## SERVICE LETTER 182

### FIREBOSS STRUT ATTACH HARDWARE REPLACEMENT

<b>Aircraft Makes/Model(s):</b>	<b>Float Model(s):</b>	<b>Compliance:</b> Mandatory	<b>By:</b> RCG
Air Tractor AT-802, AT-802A	10000A	<b>Part Number:</b> 1009711	<b>Approved:</b> JRS
		<b>Date:</b> 5/2/2018	<b>Revision:</b> A

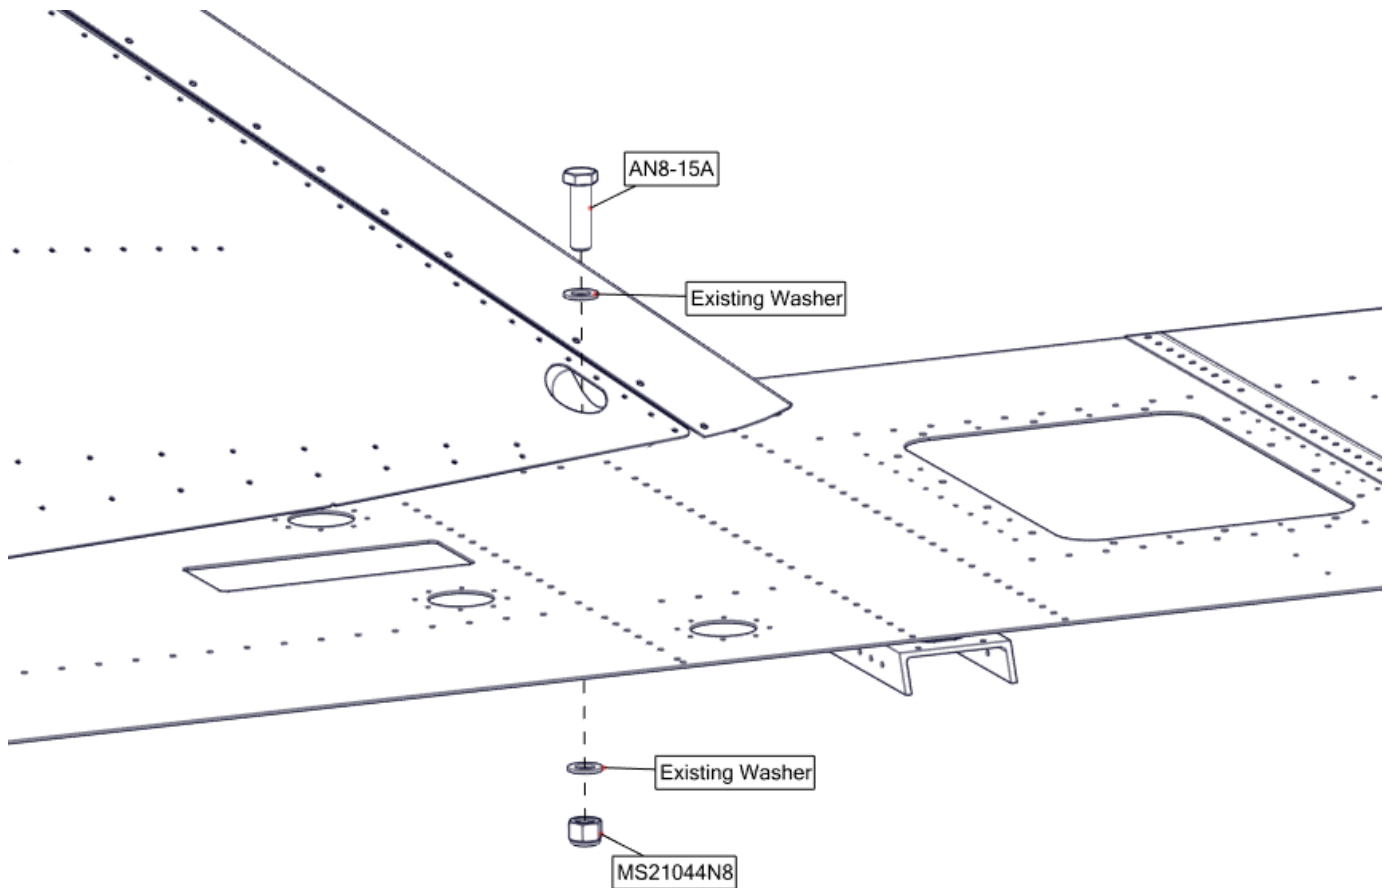
Existing hardware loosens and is wearing on the mounting hole. The hardware is being replaced with different style hardware.

Replace existing hardware as shown in the Work Instruction section of this service letter.

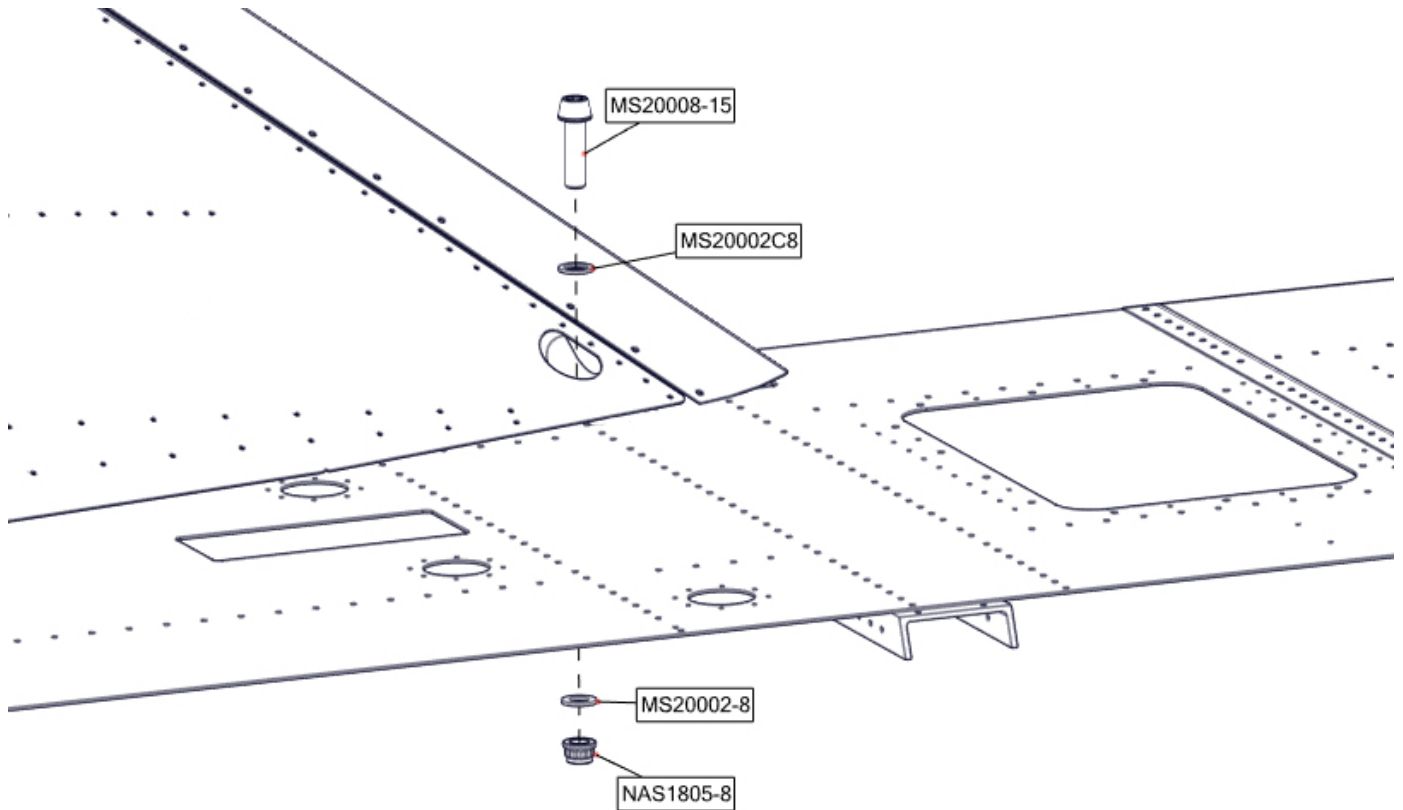
1. Defuel aircraft
2. Position and secure aircraft for maintenance
3. Remove weight off pylon and provide for support of float once drag strut attachment hardware is removed
4. Remove access cover between bulkheads 18 and 19
5. Remove hardware shown

6. Inspect hole in drag strut and top deck for wear. If hole is worn, comply with Wipaire Service Letter 145

7. Replace removed hardware with the following hardware as shown

8. Torque MS2008-15 to a maximum of 75 ft/lb  
9. Coat hardware with corrosion inhibitor  
10. Reinstall access cover between bulkheads 18 and 19 and prepare aircraft for return to service  
11. Upon completion of inspection, enter information in Aircraft Logbook for completion of this Wipaire service letter.  
12. Visit [www.wipaire.com](http://www.wipaire.com) and update your aircraft service letter/kit record using the link found on the Customer Support dropdown menu under "Update Service Letter & Kit Compliance Status."
